09-AFC-9

SUBJECT: Proposed Solar Millennium Ridgecrest Solar Power Project (SMRSPP), Docket Number 09-AFC-9

Thank you for providing the opportunity to comment on the Staff Assessment and Draft Environmental Impact Statement (SA/DEIS) prepared for the proposed Ridgecrest Solar Power Project (RSSP). I have a few comments regarding Section 5.17 of the SA/DEIS. These comments are specifically directed toward the numerical modeling, model interpretation and graphical presentation of the model results that are used in support of a 'no impact' finding to the Indian Wells Valley (IWV) groundwater resources resulting from the construction and subsequent operation of the SMRSPP.

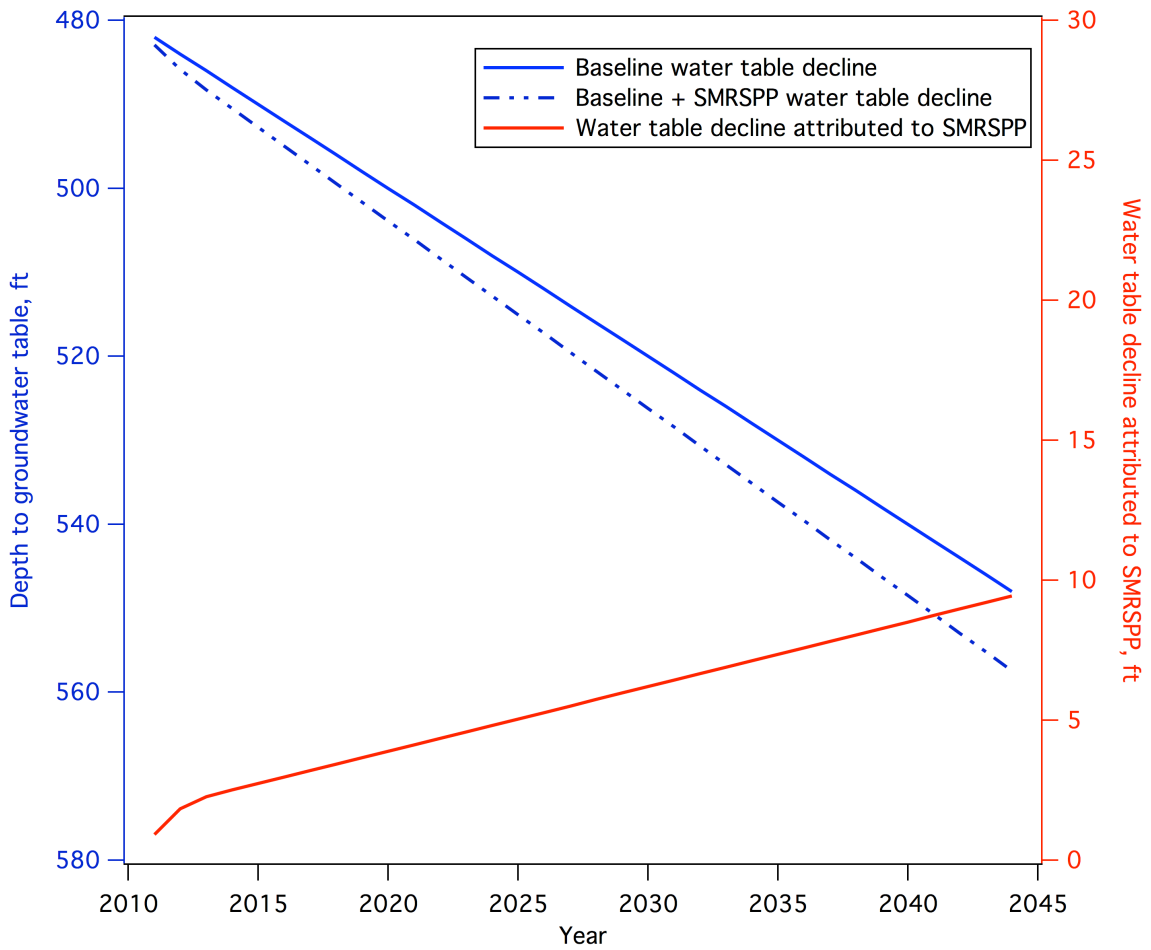
This calculation process was ported into a spreadsheet that in turn was used to compute the cumulative impact of water withdrawal from construction and subsequent operation of the plant. The results of this spreadsheet calculation are shown in the following figures. Using SM’s estimate of 1,500 af total construction water, 170 afy for construction workers for 28 months, and 204.4 afy for operations and plant workers, the total cumulative construction and operational water table decline is over 9-feet after 30-years, shown as the red line attached to the right axis in Figure 1.

Figure 1: Projected groundwater table decline following a cumulative calculation of construction and operational water consumption. Construction water consumption 1,500 af total, 170 af for construction workers for 28 months, and 204.4 af for plant operations and plant workers per SM SA/DEIS. The right axis and the red line illustrates the estimated water loss resulting from the SMRSPP being constructed and operated for 30 years. There is clearly an impact, contrary to the claim made by SM in Section 5.17 of the SA/DEIS.

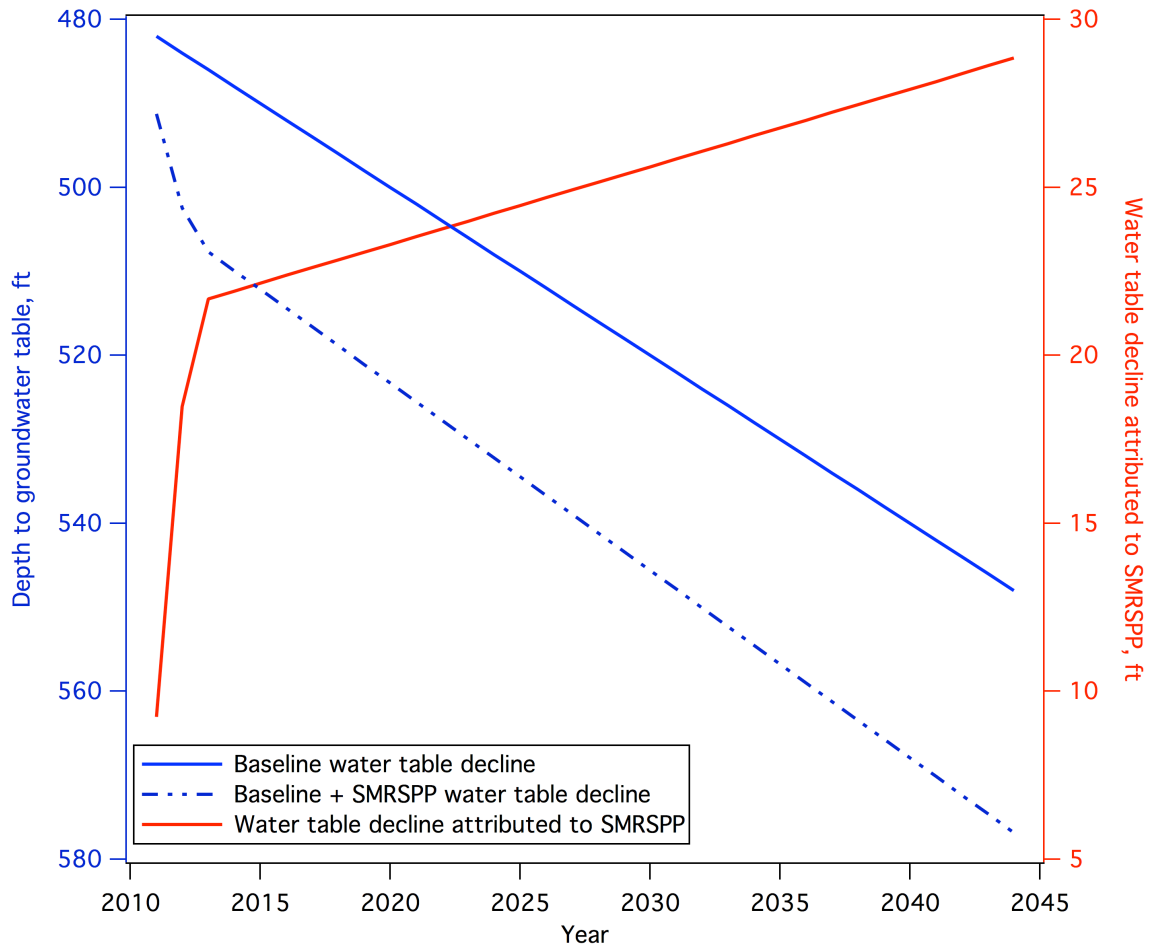
Now at the other end of the construction water use estimate is the 8,000 afy estimated by CEC staff⁴ that results in a very significant amount of water lost to the existing water users of the IWV with a total water table decline of almost 29-feet as shown in Figure 2.

Figure 2: Projected groundwater table decline following a cumulative calculation of construction and operational water consumption. Construction water consumption 8,000 afy, 170 afy for construction workers for 28 months, and 204.4 afy for plant operations and plant workers per CEC.⁴ The right axis and the red line illustrates the estimated water loss resulting from the SMRSPP being constructed and operated for 30 years. There is clearly an impact, contrary to the claim made by SM in Section 5.17 of the SA/DEIS.
